REMARKS

AMENDMENTS TO THE DRAWINGS

Figure 1

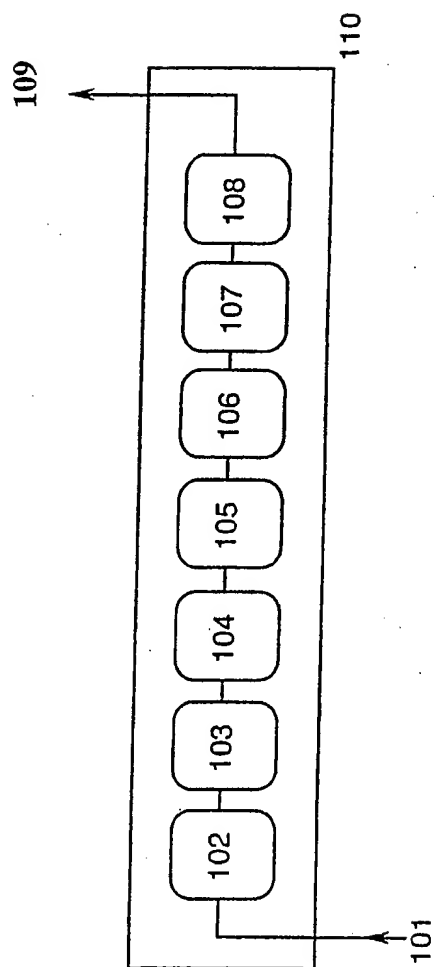
In Figure 1:

Replace reference sign "609" with "109".

Figure 2

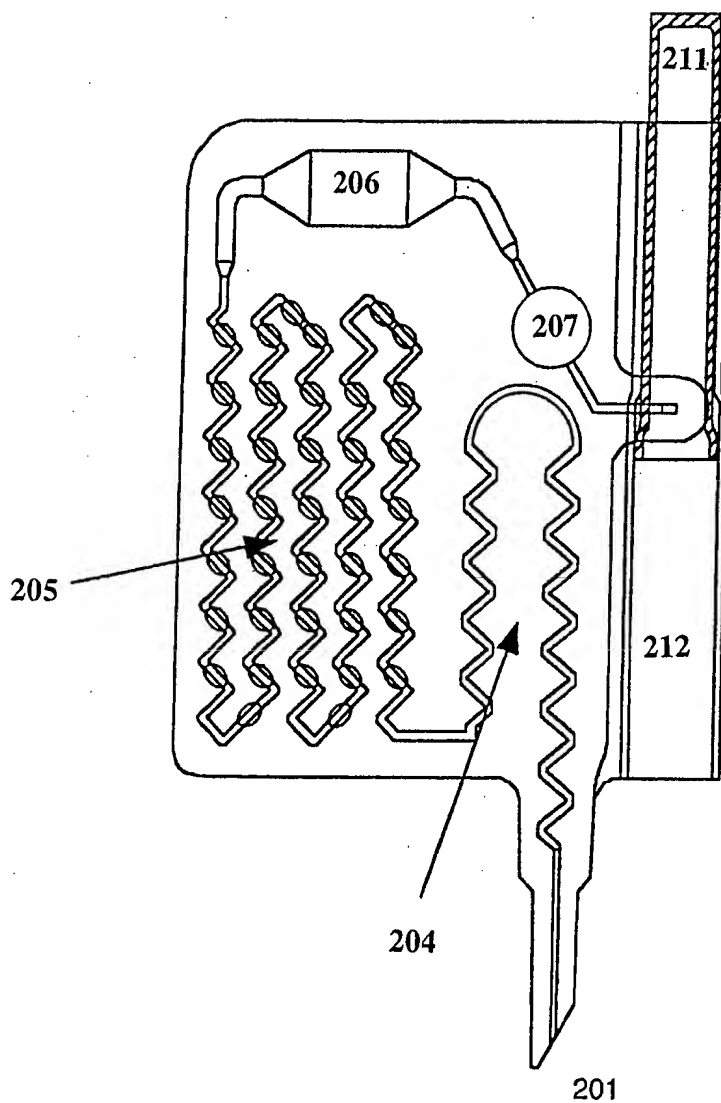
In Figure 2:

Replace reference sign 202 with 204;

Replace reference sign 203 with 205;

Replace reference sign 204 with 206;

10 Replace reference sign 205 with 207;

Replace reference sign 206 with 211; and

Replace reference sign 207 with 212.

Figure 3

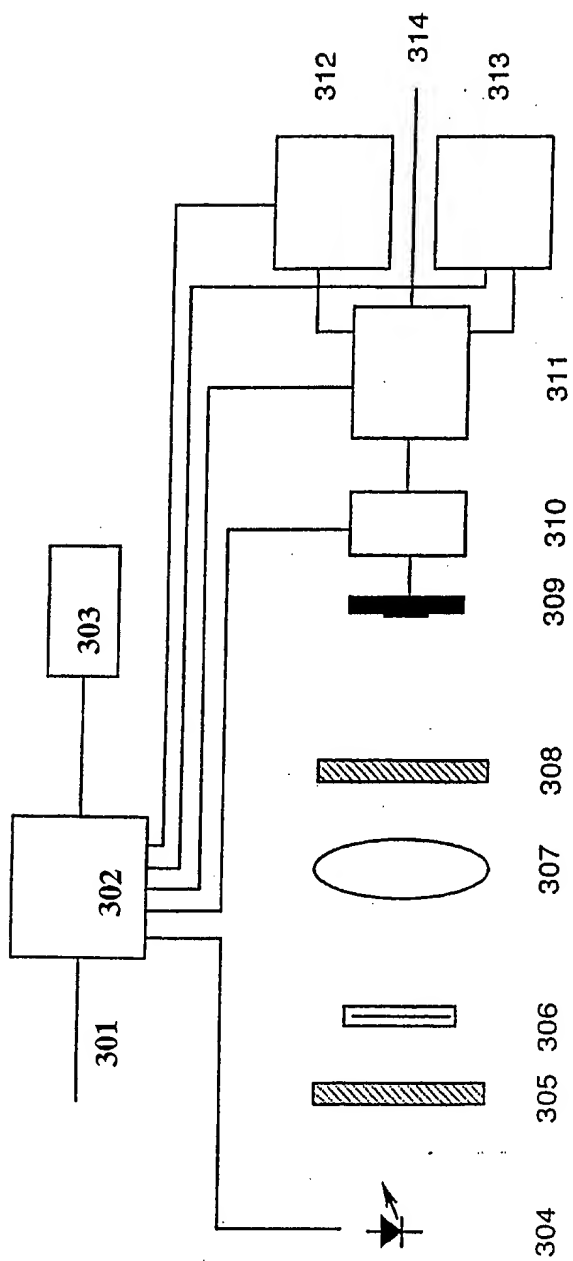
In Figure 3:

15 Replace reference sign 801 with 301;

Replace reference sign 802 with 302; and

Replace reference sign 803 with 303.

Figure 6

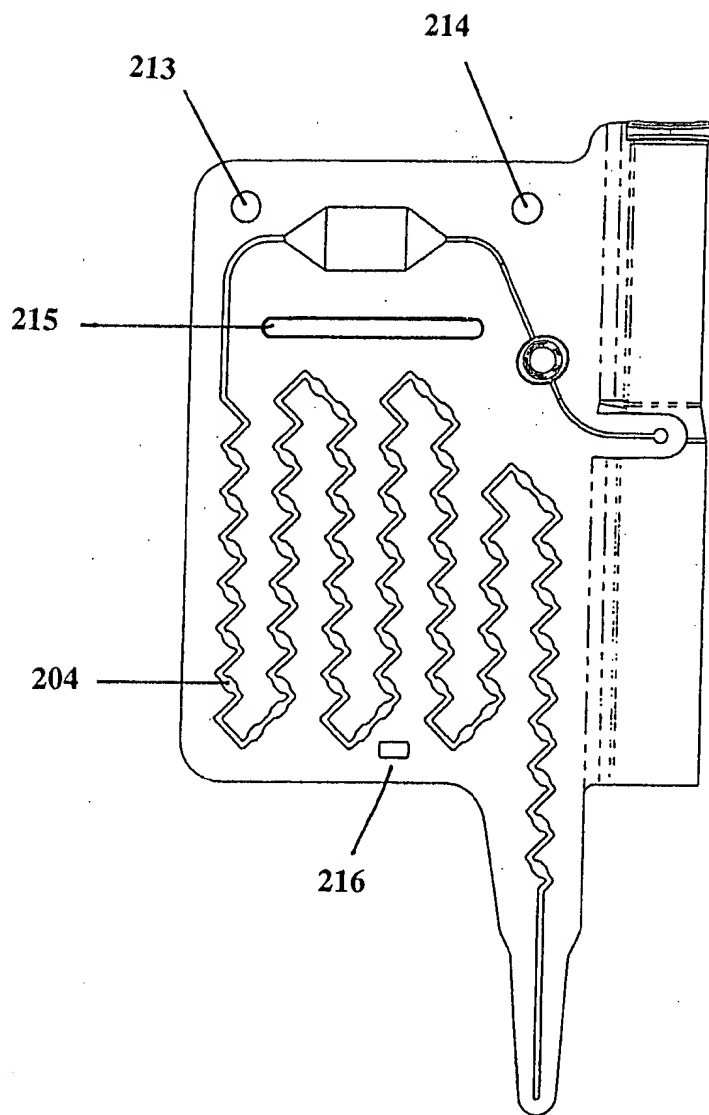
In Figure 6:

20 Add reference sign 204, 213, 214, 215, and 216 where
indicated in the replacement drawing.
